September 12, 1988
5000-88-1633

Subject: Oyster Creek Nuclear Generating Station (OCNGS)
Docket No. 50-219
License No. DPR-16
Oyster Creek Drywell Containment

ATTACHMENT
OYSTER CREEK
UPPER DRYWELL REGION
SUPPLEMENTAL INFORMATION

FIGURE 1

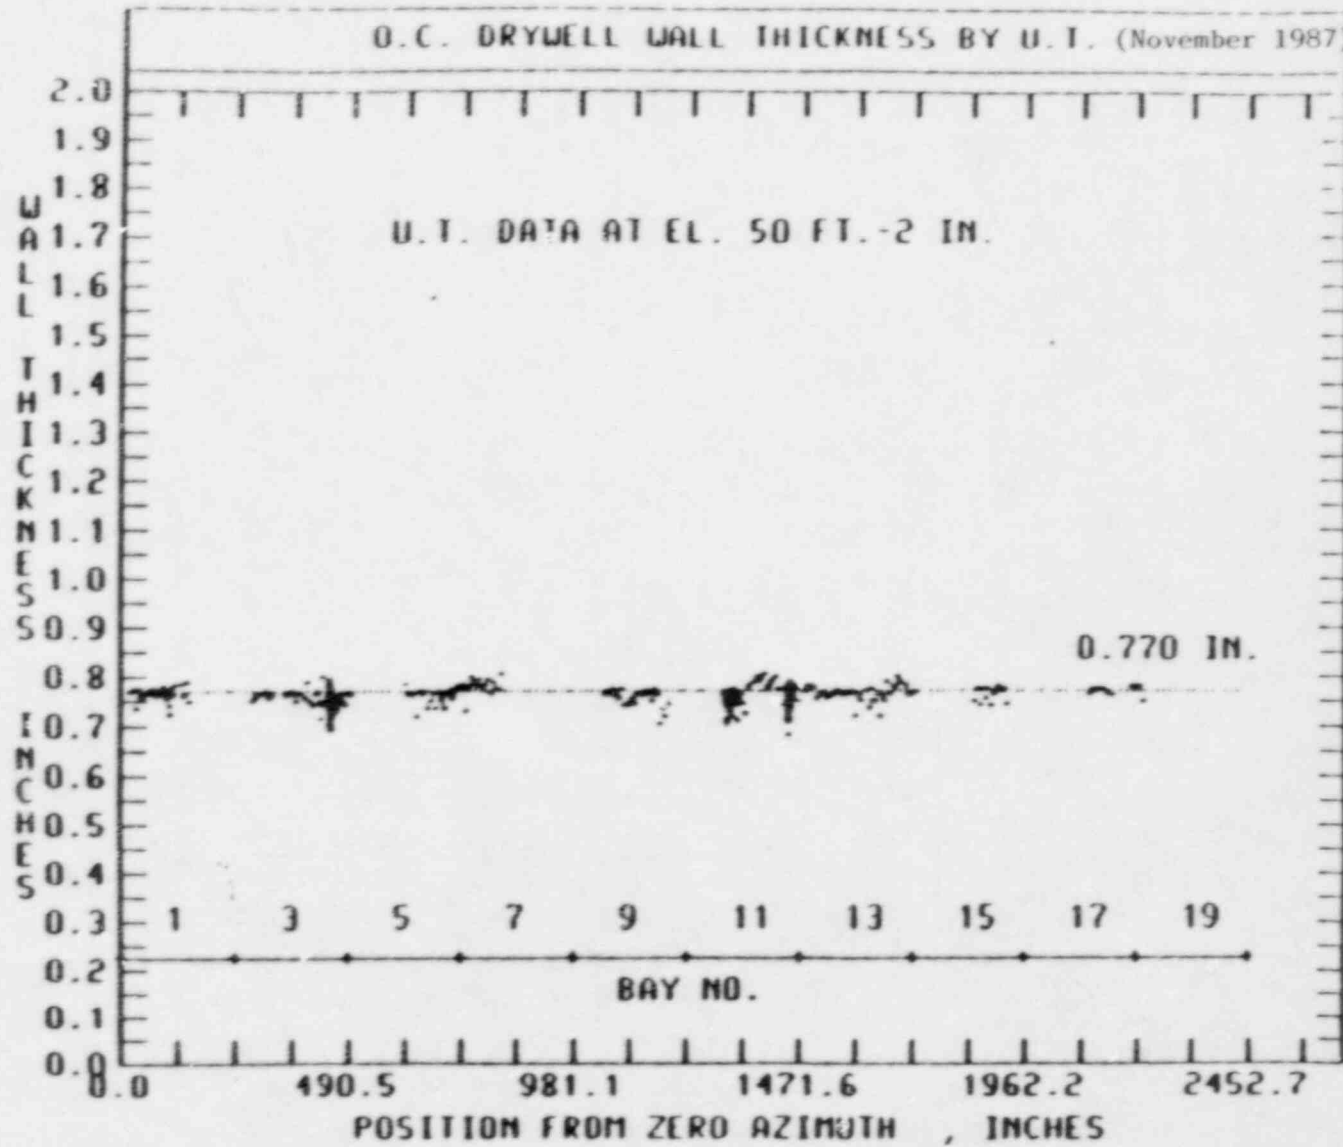
- 2) Request: Document the basis for not inspecting the drywell at the 75'-0" elevation.

UT indicated that, at the 50'2" and 87'5" elevations, the drywell wall had undergone general corrosion at some locations with isolated pits (see figures 1 and 2). Remember that general corrosion of carbon steel is merely a progression of pits. The lowest average grid thickness at elevation 50'2" was 0.757" and at elevation 87'5" was 0.619". The conservatively estimated wall losses were 33 and 46 mils, respectively. We conservatively applied the corrosion estimates, for safety evaluation purposes, to the entire region (circumference and height) at all elevations above the sand bed, even though we know that this extent of corrosion clearly does not exist.
